FAA 7100.41 Design Team Outcomes and Conceptual Procedures

Presentation to: DC Metroplex BWI Community Roundtable

Date: April 24, 2018

BWI TERPZ/LINSE RNAV SIDs 15L/R (Departures)

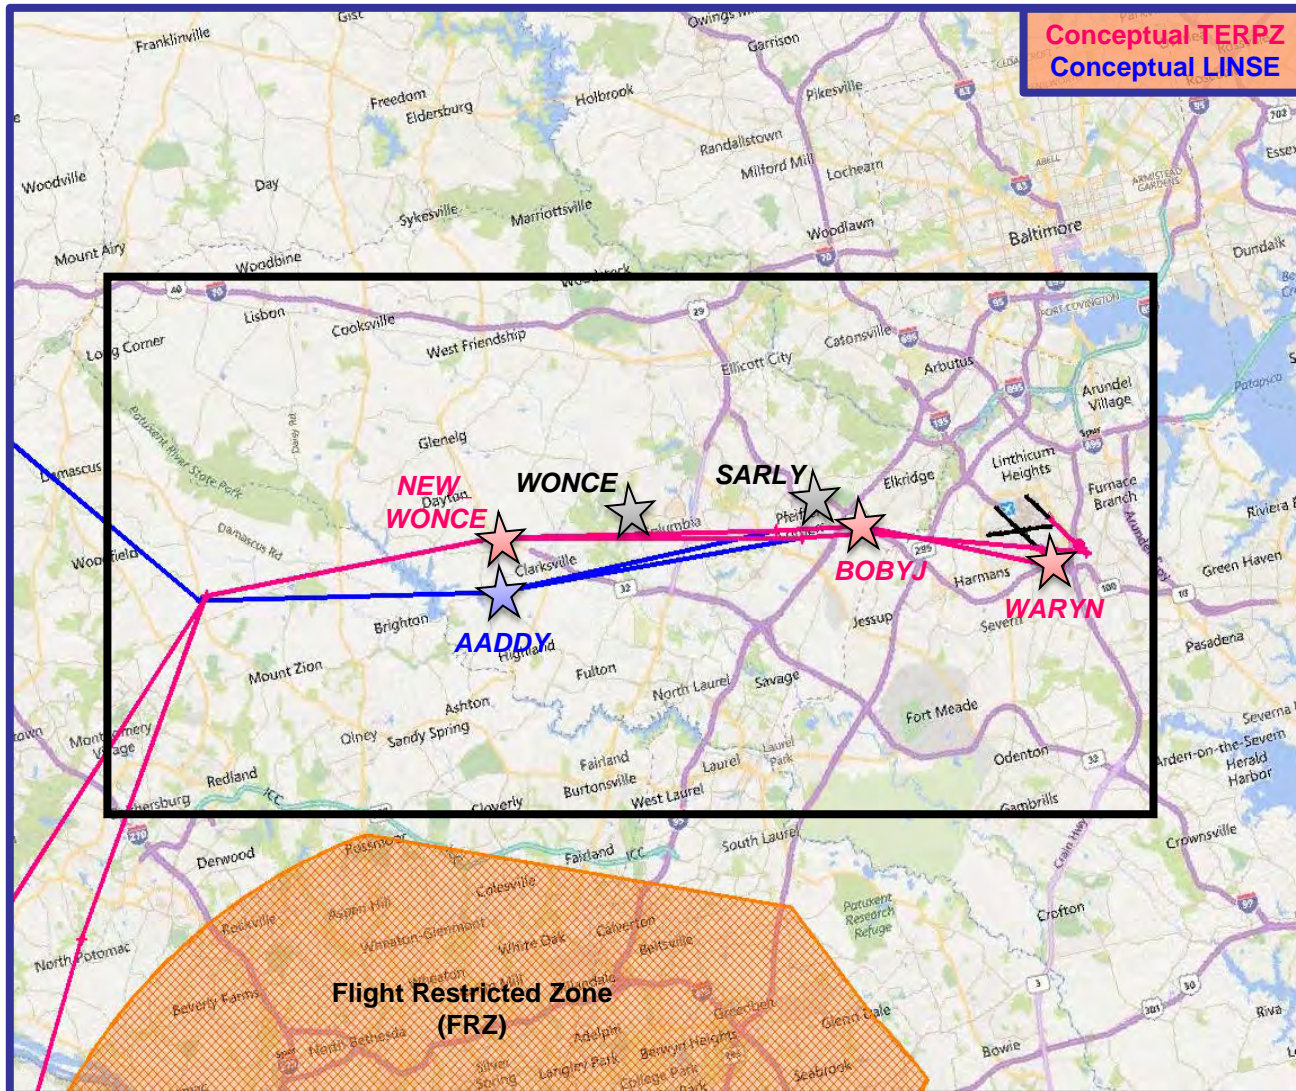
- Runway 15L/R Usage:
 - ✓ 29.1% (37,171 flights/year)
- WARYN added 0.7 nm from end of runway to conform with current voluntary noise abatement procedures (1 DME from BAL VOR)
- Design Requirements
 - ✓ Initial departure off 15R requires a non-standard climb gradient and speed restriction
 - ✓ Still requires industry concurrence and flight standards approval

BWI TERPZ/LINSE RNAV SIDs 15L/R (Departures)

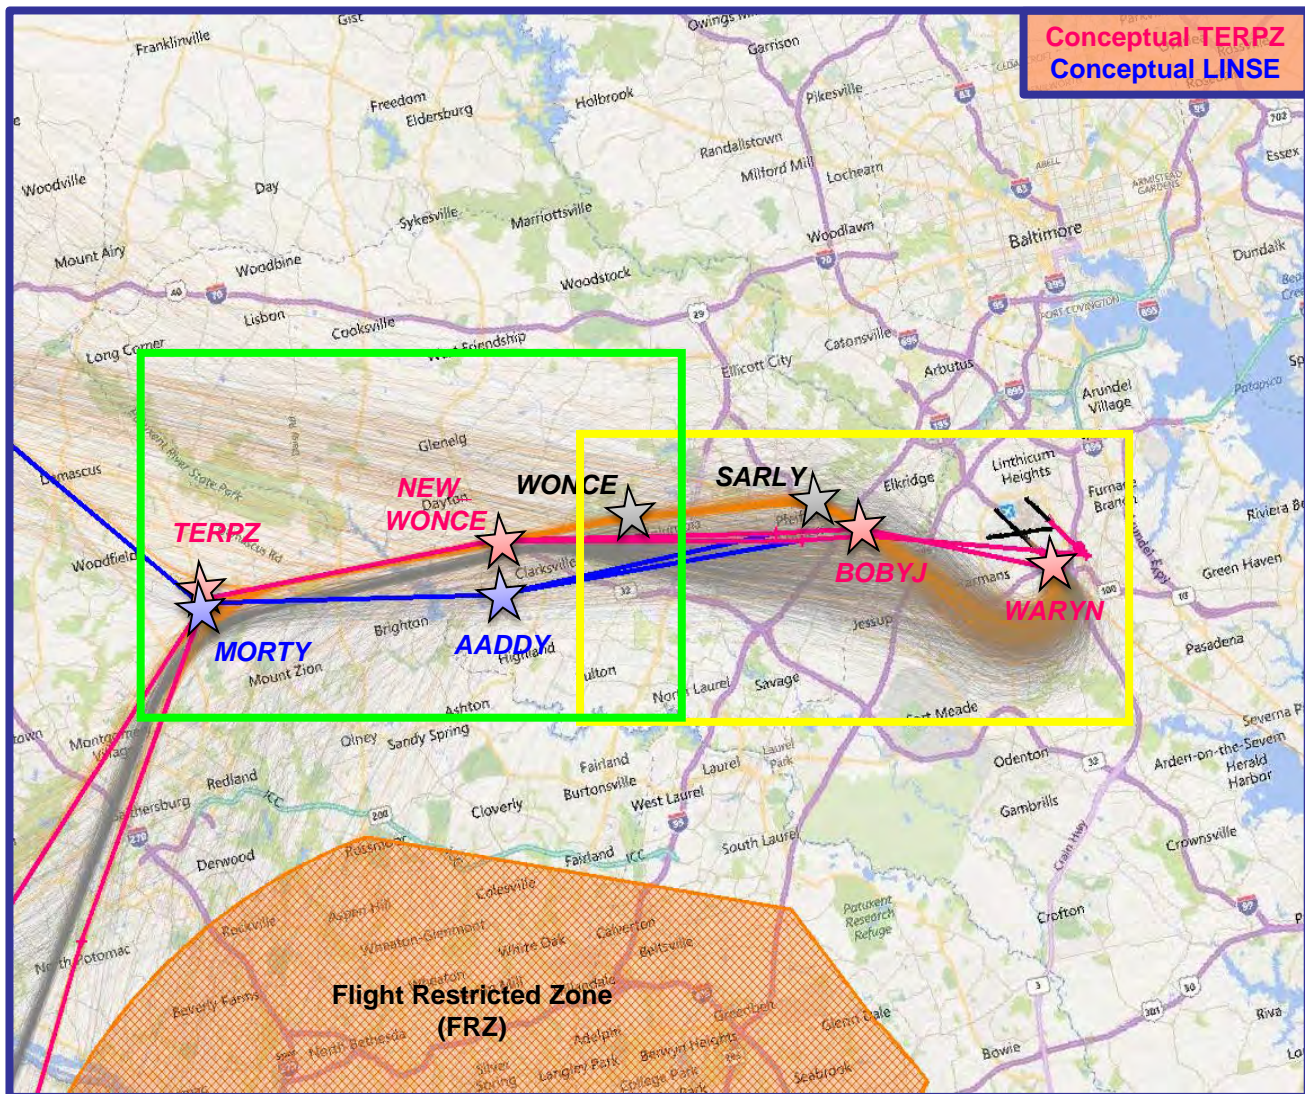
- Runway 15L/R Usage:
 - ✓ 29.1% (37,171 flights/year)
- Pre-Metroplex tracks (Feb 2012)
- **Current tracks (Feb 2017)**
- SARLY removed
- Conceptual design track moved 1.39 nm southeast at BOBYJ
- WONCE moved 3.68 nm west and temporarily named NEW_WONCE
- AADDY is on the new LINSE procedure to help mimic pre-Metroplex track dispersion
- MORTY is on the new LINSE procedure 0.2 nm southwest of TERPZ

BWI TERPZ/LINSE RNAV SIDs 28 (Departures)

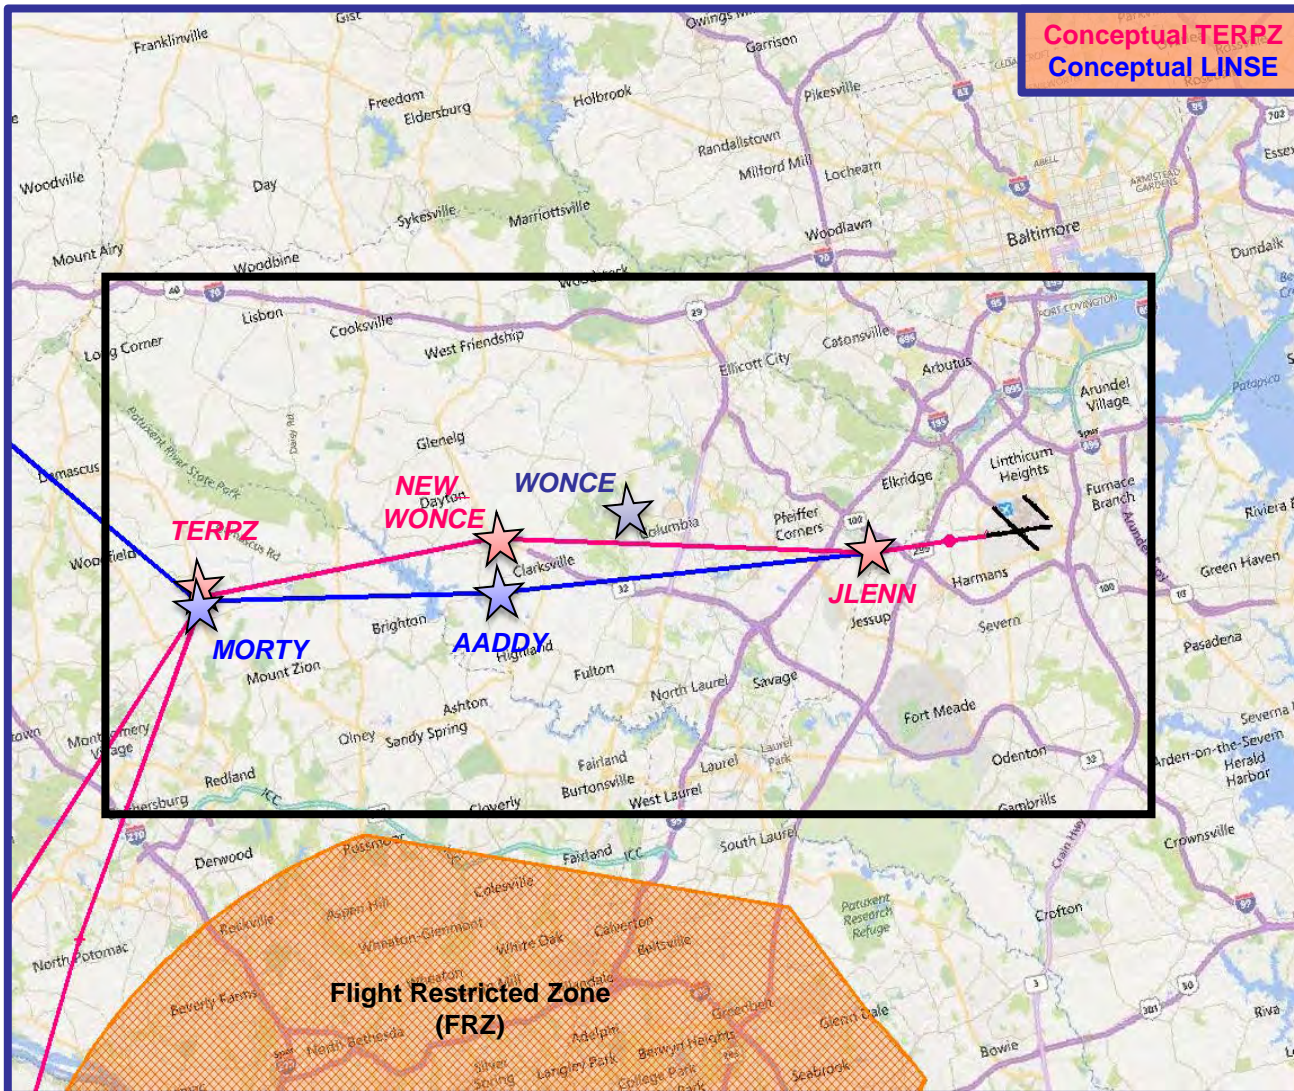
- **Runway 28 Usage:**
 - ✓ 63.4% (81,023 flights/year)
- **Conceptual TERPZ** Serves jet departures to the west and southwest
Anticipated usage = 74%
- **Conceptual LINSE** Serves jet departures to the northwest
Anticipated usage = 26%
- **JLENN** added 3 nm from the end of the runway to conform with current voluntary noise abatement procedures
- **WONCE** moved 3.68 nm west and temporarily named **NEW_WONCE**

BWI TERPZ/LINSE RNAV SIDs 28 (Departures)

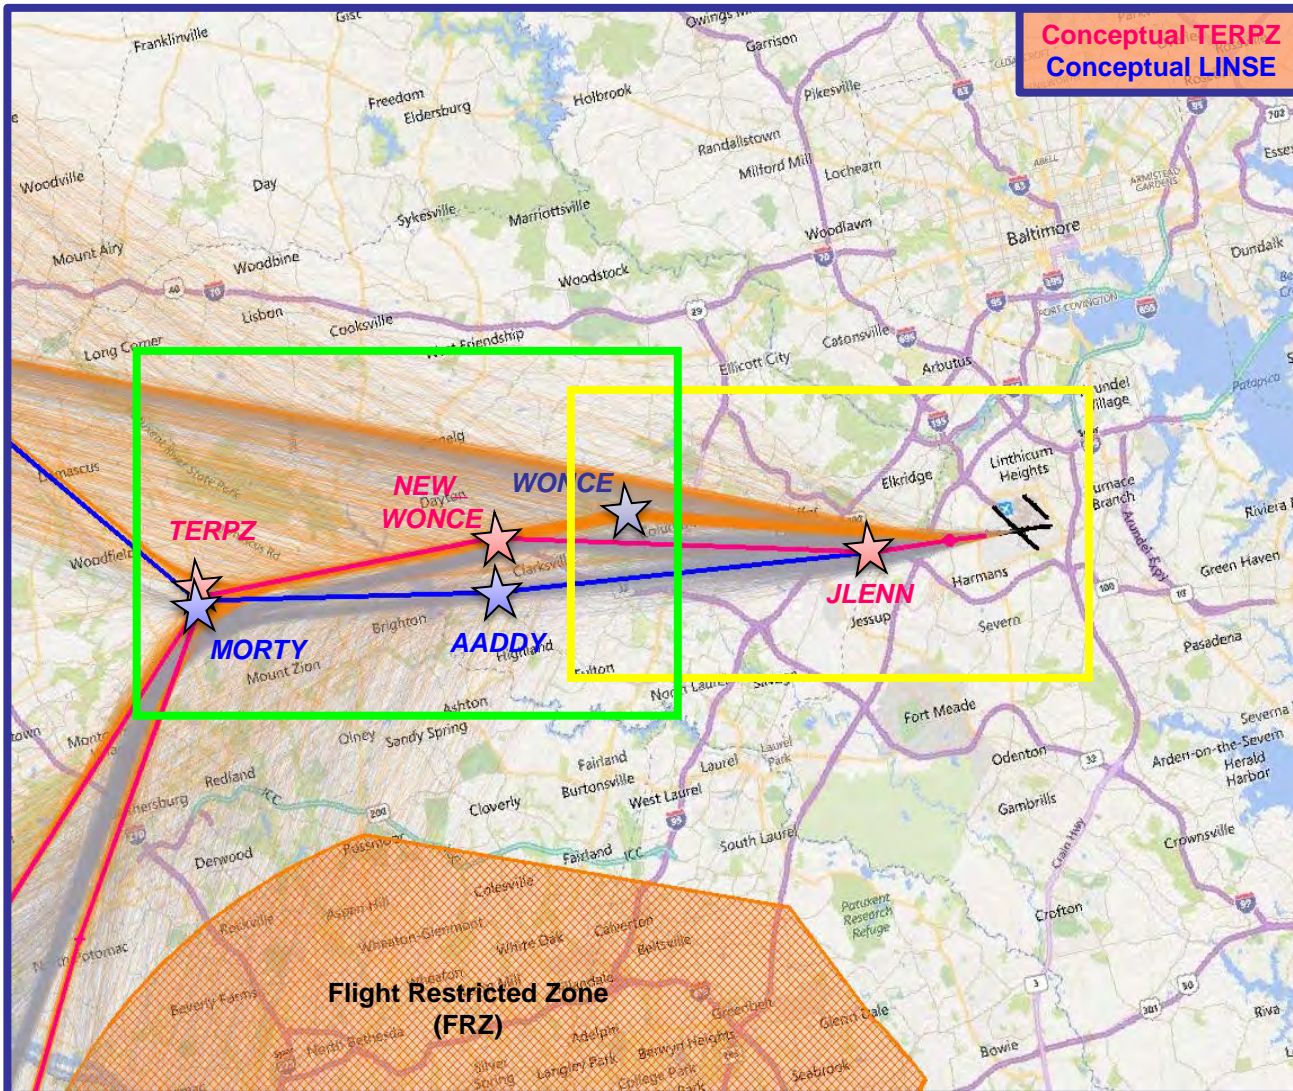
- **Runway 28 Usage:**
 - ✓ 63.4% (81,023 flights/year)
- Pre-Metroplex tracks (Feb 2012)
- **Current tracks (Feb 2017)**
- **AADDY is on the new LINSE procedure to help mimic pre-Metroplex track dispersion**
- **MORTY is on the new LINSE procedure 0.2 nm southwest of TERPZ**

BWI CONLE/FIXET RNAV SID (Departure)

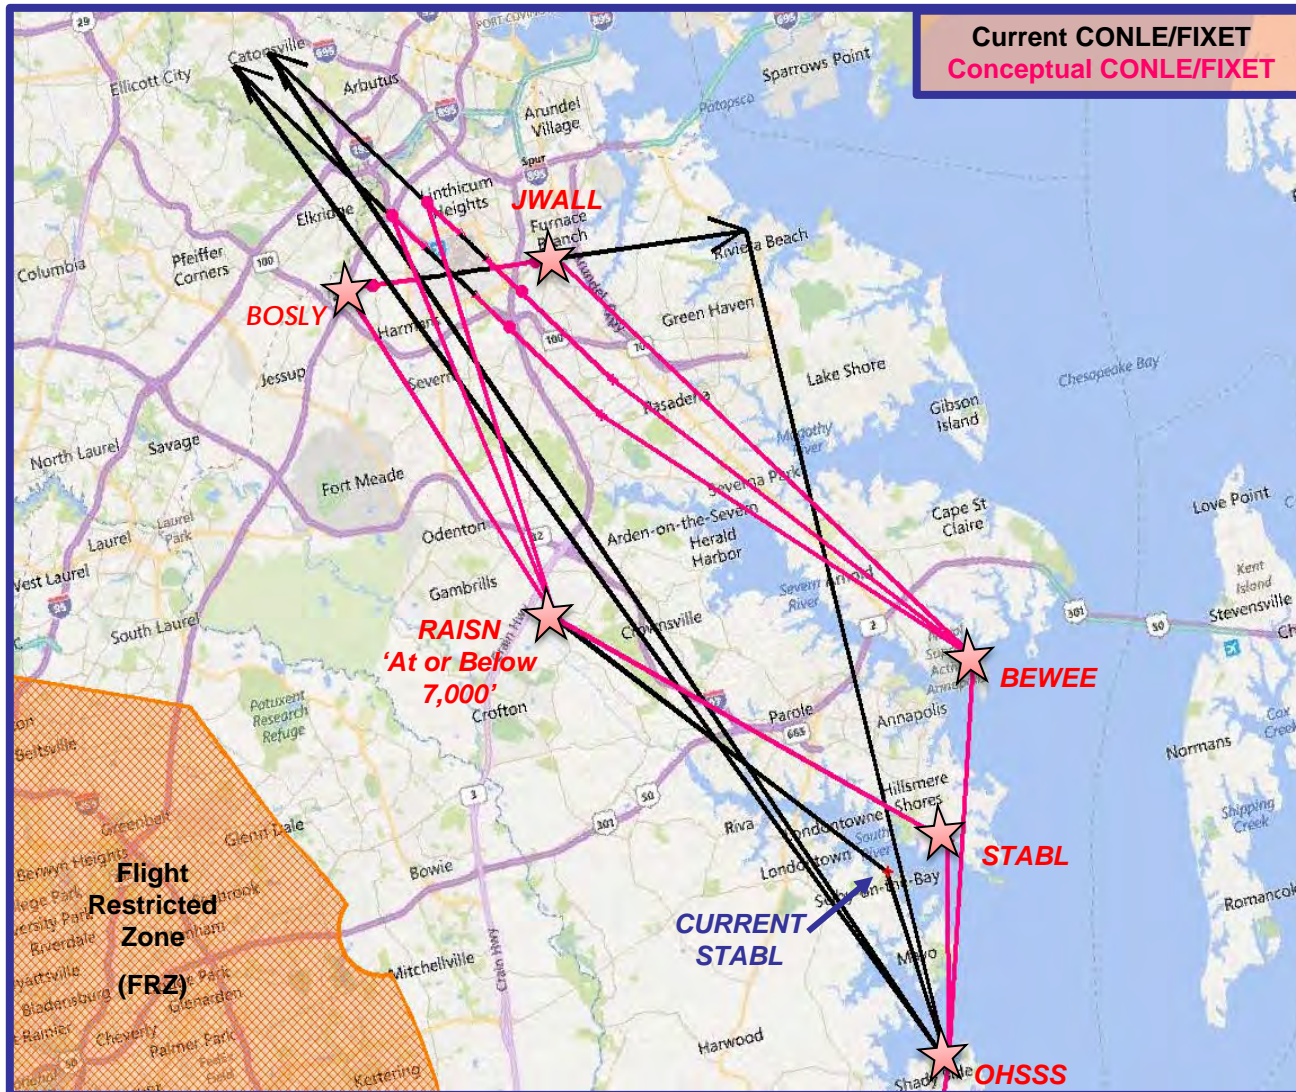
- **Conceptual CONLE**
Serves jet departures to the south
- **Conceptual FIXET**
Serves jet departures to the west and southwest during inclement weather events
- **No changes to departures off RWY 15L/R**
 - ✓ Usage: 29.1% (37,171 flights/year)
- **Runway 10 Usage:**
 - ✓ 0.5% (606 flights/year)
- **Runway 10 Changes:**
 - ✓ **Current** – Depart heading 105 with RADAR vectors to OHSSS
 - ✓ **Conceptual** - JWALL added 1 nm from end of RWY 10 for conformance with voluntary noise abatement procedures and to utilize climb via
 - ✓ After JWALL procedure goes direct BEWEE, direct OHSSS

BWI CONLE/FIXET RNAV SID (Departure)

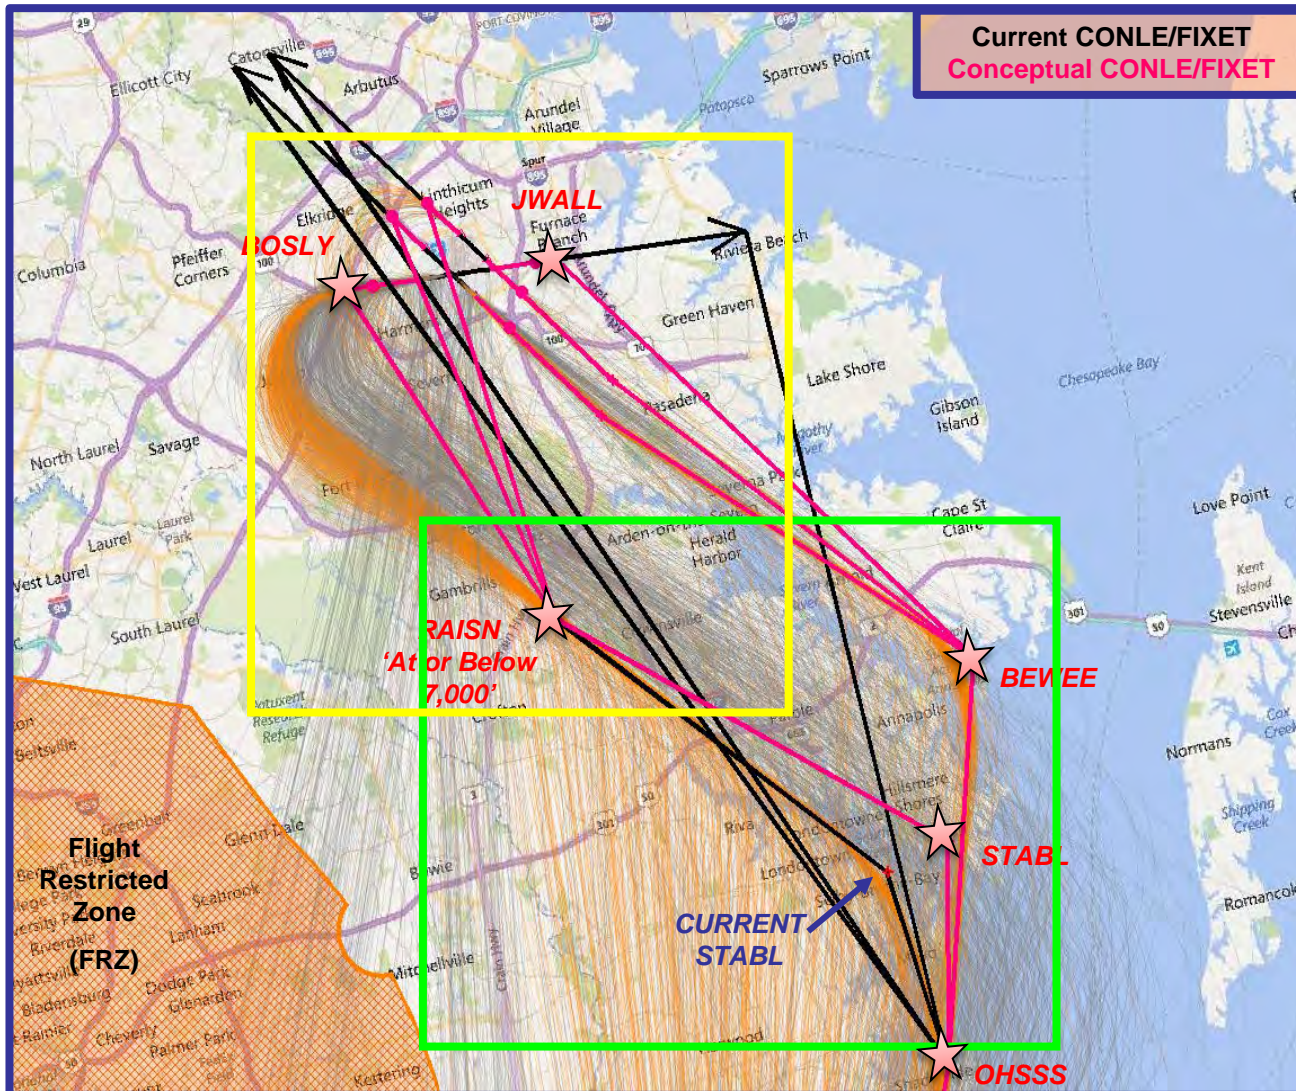
- **Runway 28 Usage:**
 - ✓ 63.4% (81,023 flights/year)
- **Runways 33L/R Usage:**
 - ✓ 7.1% (9,043 flights/year)
- **Runways 28 and 33L/R Changes:**
 - ✓ Altitude restriction 'At or Below 7,000' ft added at RAISN for climb via clearance
 - ✓ STABL moved 1.59 nm east for criteria
- Pre-Metroplex tracks (Feb 2012)
- **Current tracks (Feb 2017)**

T-Route 356

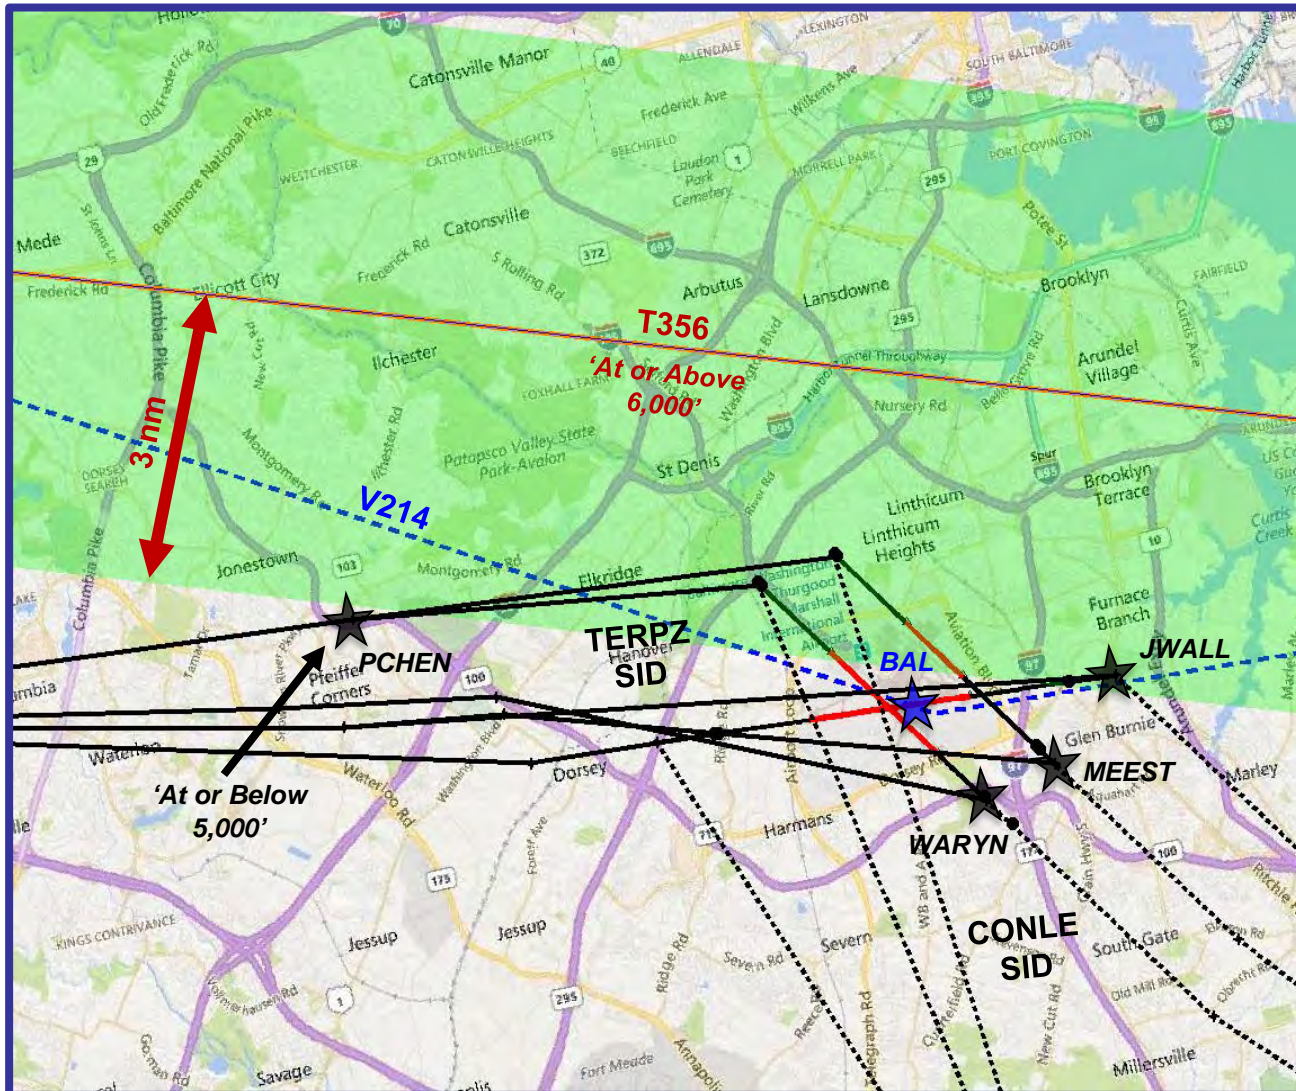
- T356 will allow BWI Tower to issue a Climb Via clearance
- Climb Via clearance allows for a pre-determined, repeatable, and efficient climb
- Currently, Runway 33L/R departures climb to 4,000 ft and level off
- Conceptual procedure will allow for a Climb Via clearance to 14,000 ft
